From: mpaarchitecture@gmail.com on behalf of elliott pardington <elliott@mpaarchitecture.co.uk>
Sent: 05 July 2012 14:43
To: Hannah Barker
Cc: s.cumbers
Subject: 102 Beach Green, Shoreham by Sea - AWDM/0655/12
Attachments: 04 Proposed - Rev A.pdf

102 Beach Green
Shoreham by Sea
East Sussex
BN1 5LS

Proposed plans

786/04 A

Ground Floor Plan, 1:50

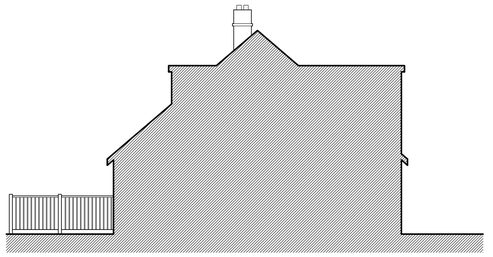
The ramp width and landing length have both been increased to 1500mm. The ramp has also been indicated as having a gradient of 1 in 15. Based on an overall rise in the region of 150mm, this will give a ramp length in the region of 2250mm.

A	Ramp gradient reduced, width and landing increased	July 2012
Revisions :	Description :	Date :
